ADDRESS OF PROPERTY: 816 Brookside Avenue

SUMMARY OF REQUEST: Second Story Dormer/rear 2-floor addition/tree removal

THIS APPLICATION WAS DEFERRED ON FEBRUARY 12, 2014 FOR THE FOLLOWING:

Charlotte Historic District Commission - Case 2014-008

View of left side elevation from street

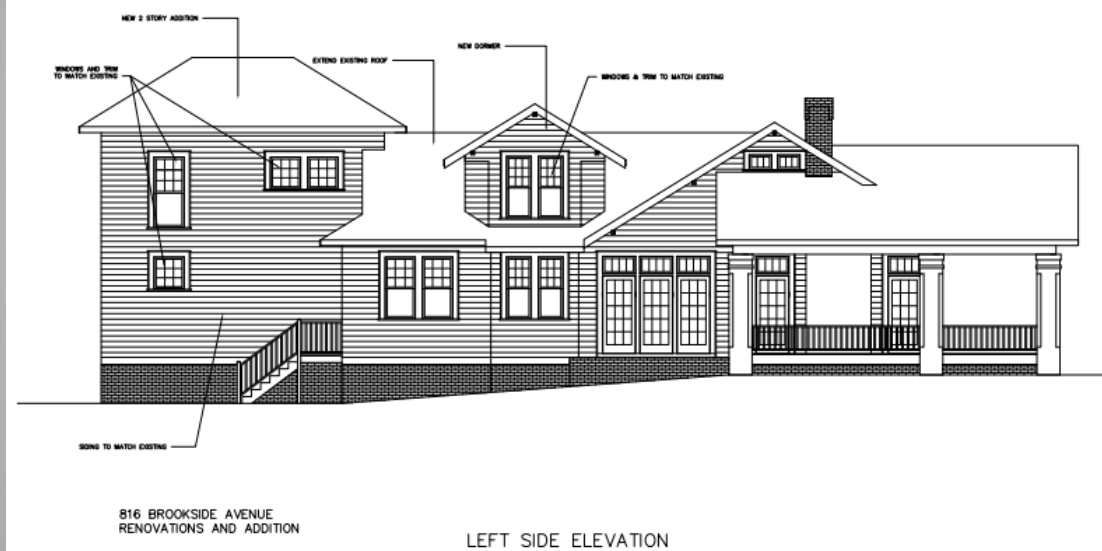
Replacing large windows with tiny windows

PORCH SECTION

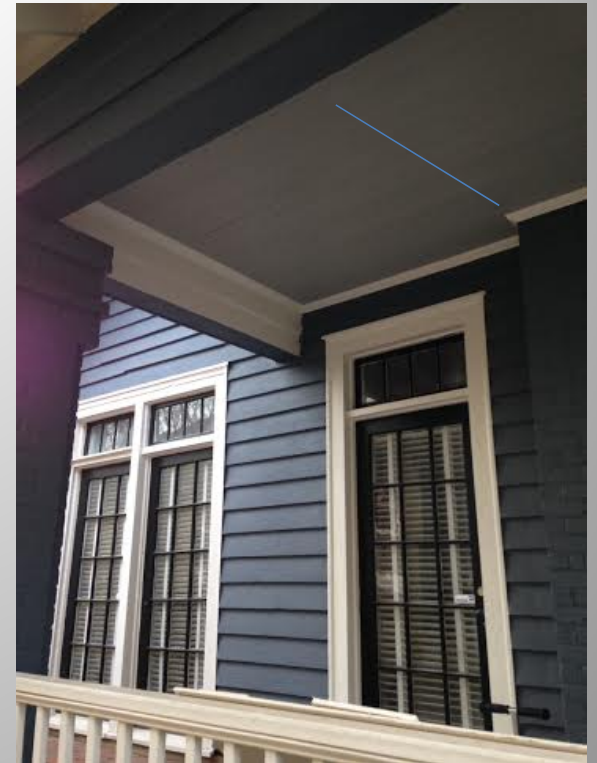
Additional Window with vaulted side porch ceiling

Section where ceiling to be vaulted and window added above door

First Floor plan – rear of home

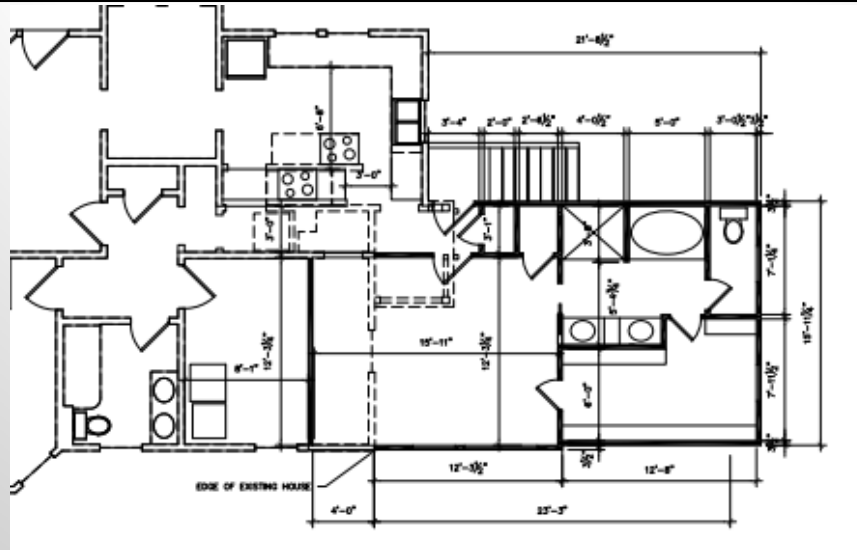
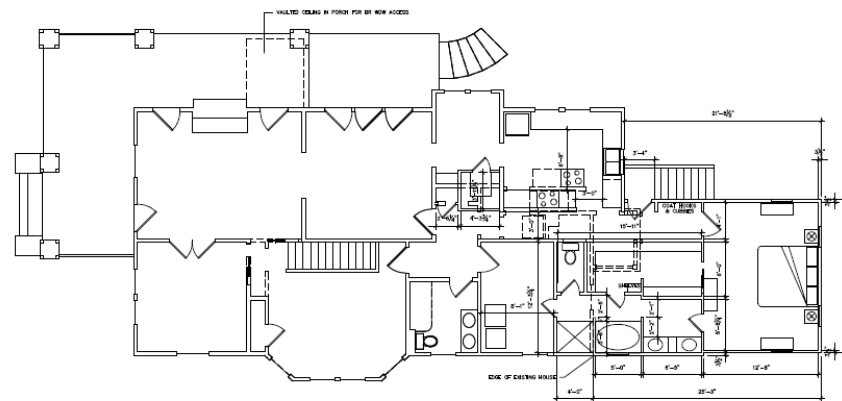
Proposed changes
to accommodate
HDC-requested
windows
